Appendix C-2 IESC Comments and Response

Appendix C-2 - Responses and Clarifications to IESC Questions

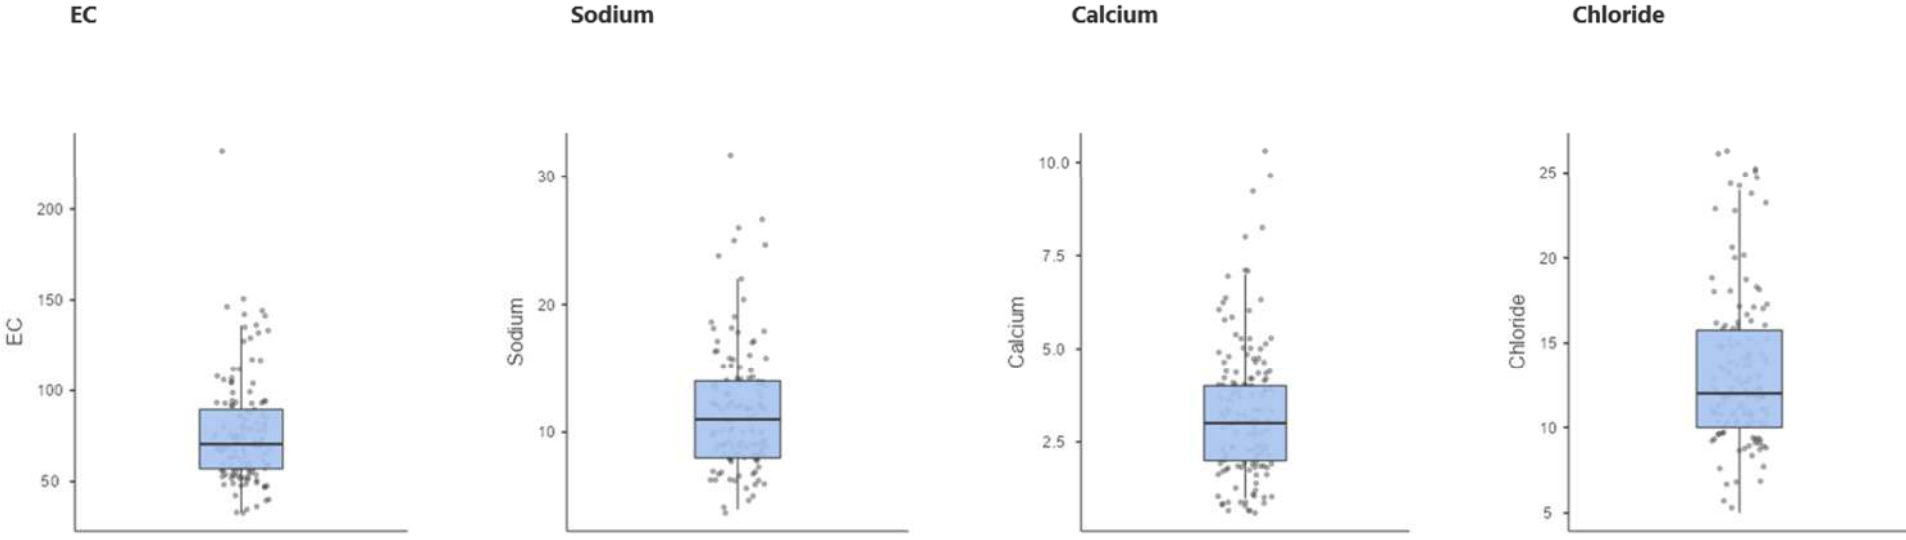
<p>b. The treated water releases will potentially impact the tributary, waterhole and Dawson River downstream. The potentially impacted area extends from the desalinated water release point (blue dot in Figure 5.1, AECOM 2022, p. 70) to the confluence with the Dawson River just upstream of DRMP1 (AECOM 2022, Figure 5.1, p. 70) and downstream.</p>	<p>Desalinated water releases proposed for the Gas Field Development (GFD) Project are an extension of existing water releases for the Gladstone Liquefied Natural Gas (GLNG) Project (EPBC 2008/4059) as described in Section 1.1 of the PD. Desalinated water releases to the waterhole and subsequently the Dawson River have occurred since 2015 and have been monitored and assessed under the existing REMP since that time.</p> <p>Water generation from the Fairview gas field is dynamic and variable depending on CSG well numbers and production rate. Water management of coal seam gas water prioritises beneficial reuse of water consistent with the Queensland Government Coal Seam Gas Water Management Policy (DEHP, 2012). Beneficial use data for 2021 indicates produced water end uses are:</p> <ul style="list-style-type: none"> • 60% is used irrigation • 10% for operational activities such as dust suppression, construction, drilling etc) • 5% is lost to net evaporation • 5% as stored water including brine and • 20% released as desalinated water to the Dawson River. <p>Produced water is treated at the Hub Compressor Station 04 (HCS04) water treatment plant via reverse osmosis (RO) to reduce salinity and chemicals. Water treatment is designed to meet EA prescribed pre-release "contaminant limits (CL) for protecting the Environmental Values (EV) for Drinking Water" (see below). The treatment process is described in Section 2.2.1.4 of the PD and summarized in the response to Question 13.</p> <p>Treated desalinated water is discharged to an ephemeral gully to bring it into equilibrium with ambient temperature and dissolved oxygen conditions prior to entering the waterhole and subsequently entering the Dawson River. Schedule B of the EA defines maximum contaminant limits for treated water that are:</p> <ol style="list-style-type: none"> a) below acute toxicity limits prior to discharge at the head of gully release point – Schedule B Table 4; and b) protection of the drinking water EV at the compliance point S4 at Yebna Crossing – Schedule B Table 5 <p>Predicted P50 desalinated water inflow to the ROP plant for both the GLNG and GFD projects and the forecast Dawson River discharge requirements are provided in Section 2.3.2 of the PD document and are presented in the following graph.</p>	<p>Section 2.2 Section 9.0</p>

No	IESC COMMENT	Response and /or Clarification	Clarification location in PD
		 <p>P50 model for ROP2 inflow from GLNG (green) and GFD (grey) projects</p>  <p>P50 Forecast Monthly Dawson River release plot to 2035</p> <p>The REMP program presented in Appendix J (and reported in Appendix F) of the PD is required by the State EA (Condition B36 to B41) to monitor the receiving environment for potential impact and where required, implement actions and responses triggered by REMP data. REMP monitoring has included ecosystem health monitoring based on SIGNAL 2 scoring (Stream Invertebrate. Grade Number - Average Level1 - scoring system) for both the waterhole and Dawson River upstream and downstream of the desalinated water confluence. Ongoing desalinated releases in accordance with State EA condition requirements under the GFD Project have been found unlikely to significantly change the existing condition of the receiving environment that has been receiving treated desalinated water from the GLNG Project since 2015.</p>
